# Access Compliance Report

## Public Rights-of-Way

Intersection ID: 5574	Main Street: BANNER_ELK_DR	Cross Street: SUNSET_RD	Location: SW
ADA ID: 0BB1AED534E1	Ramp Type: Perp	Initial Pass/Fail: Pass	Overall Compliance: No
		Severity Score: 0

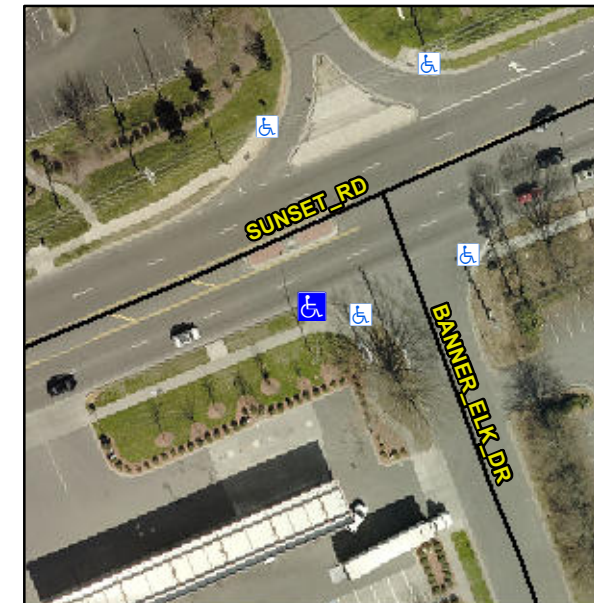
Compliance	Description	Data	Compliance	Description	Data
N/A	Ramp Length (in)	96.0	Yes	Ramp Slope (%)	6.4
Yes	Ramp Width (in)	48.0	Yes	Ramp XSlope (%)	0.9
N/A	Flare Type LT	Sloped	N/A	Flare Type RT	N/A
N/A	Flare Slope LT (%)	4.1	Yes	Flare Slope RT (%)	2.5
N/A	Flare Traversable LT?	Yes	N/A	Flare Traversable RT?	Yes
Yes	Landing Length (in)	71.0	Yes	DWS Provided?	Yes
Yes	Landing Width (in)	53.0	Yes	DWS Contrast?	Yes
Yes	Landing Slope (%)	0.2	Yes	DWS Length (in)	24.0
Yes	Landing X Slope (%)	1.1	Yes	DWS Full Width?	Yes
N/A	Landing Curb? (Y/N)	No	Yes	DWS Offset (in)	0.0
N/A	Shared Landing?	No			
Yes	Gutter Ponding?	No	Yes	Gutter Slope (%)	0.5
Yes	Gutter Lip Ht (in)	0.0	Yes	Gutter X Slope (%)	0.7
N/A	Painted X Walk1?	No	N/A	Painted X Walk2?	N/A
	X Walk 1 Direction	To N		X Walk 2 Direction	N/A
N/A	X Walk 1 Width (in)	N/A	N/A	X Walk 2 Width (in)	N/A
	X Walk 1 Slope (%)	0.9		X Walk 2 Slope (%)	N/A
	X Walk 1 X Slope (%)	2.5		X Walk 2 X Slope (%)	N/A

N/A	Ramp inside XWalk1?	N/A	N/A	Ramp inside XWalk2?	N/A
	Road Slope (%)	N/A	N/A	Clear Space?	Yes
	Road X Slope (%)	N/A	N/A	Clear Space to XWalk (in)	N/A
Yes	Any Obstructions?	No	Yes	Storm Grate/Utility Hazard?	No
	Obstruction Type			Storm Grate/Utility Type	
			N/A		N/A
			Yes	Surface Condition? (G/P)	Good

**Remove & Replace Entire Ramp.**
